HITACHI

CUSTOMER'S ACCEPTANCE SPECIFICATIONS

SX14Q001

RECORD OF REVISION

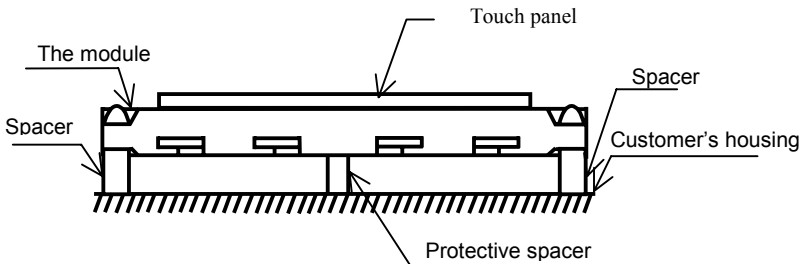
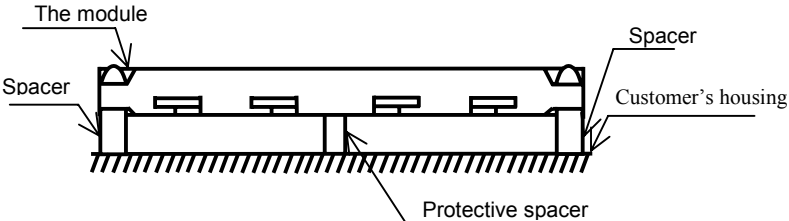
DATE	SHEET No.	SUMMARY												
May.11.'01	7B64PS2703-SX14Q001-2 PAGE 3-1/1	CHANGED: (8) Backlight (50kh life (at 25°C) and replaceable) is canceled (11) power supply voltage 3.3V only → 3.3V												
May.11.'01	7B64PS2704-SX14Q001-2 PAGE 4-2/2	CHANGED: 4.2 ENVIRONMENTAL ABSOLUTE MAXIMUM RATINGS Ambient temperature: Operating min 5°C → 0°C max 40°C → 50°C												
May.11.'01	7B64PS2709-SX14Q001-2 PAGE 9-1/1	CHANGED: 9.1 DIMENSION OUTLINE (1)  (2) FFC DIMENSION CHANGED PARTS: DETAIL A parts

<table><tr> <td>0.85±0.2</td> <td>→</td> <td>0.65±0.15</td> </tr><tr> <td>1.25±0.1</td> <td>→</td> <td>1.0±0.05</td> </tr><tr> <td>0.8±0.1</td> <td>→</td> <td>0.7±0.1</td> </tr><tr> <td>21.25±0.3</td> <td>→</td> <td>17.0±0.1</td> </tr></table>

11.1 MOUNTING PRECAUTION

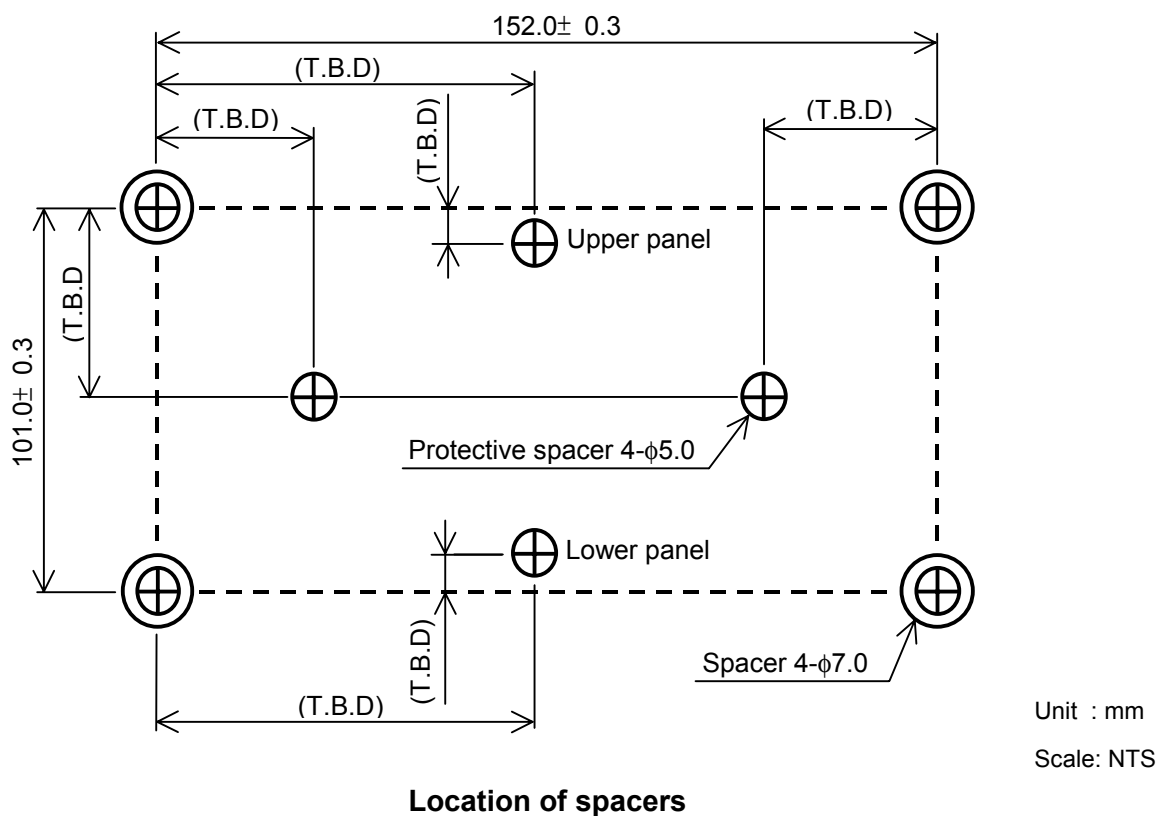
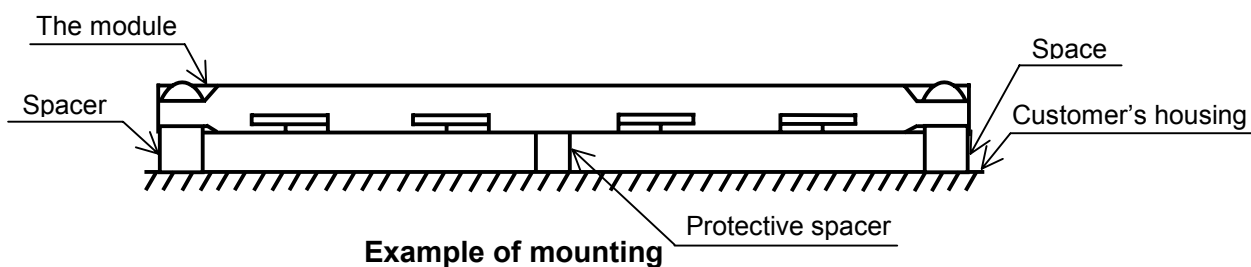
DATE	SHEET No.	SUMMARY
May.11.'01	7B64PS2711-SX4Q001-2 PAGE 11-1/3	CHANGED: 11.1 MOUNTING PRECAUTION  <u>Example of mounting</u> ↓  <u>Example of mounting</u> 11.1 MOUNTING PRECAUTION “(3) For the module to be used.....shift with its own weight.” Is canceled.
Sep.07.'01	7B64PS2709-SX14Q001-3 PAGE 3-1/1	3. GENERAL DATA Add (12)
Sep.07.'01	7B64PS2709-SX14Q001-3 PAGE 3-1/1	Update all page. FFC CONTACT SIDE : BOTTOM → TOP
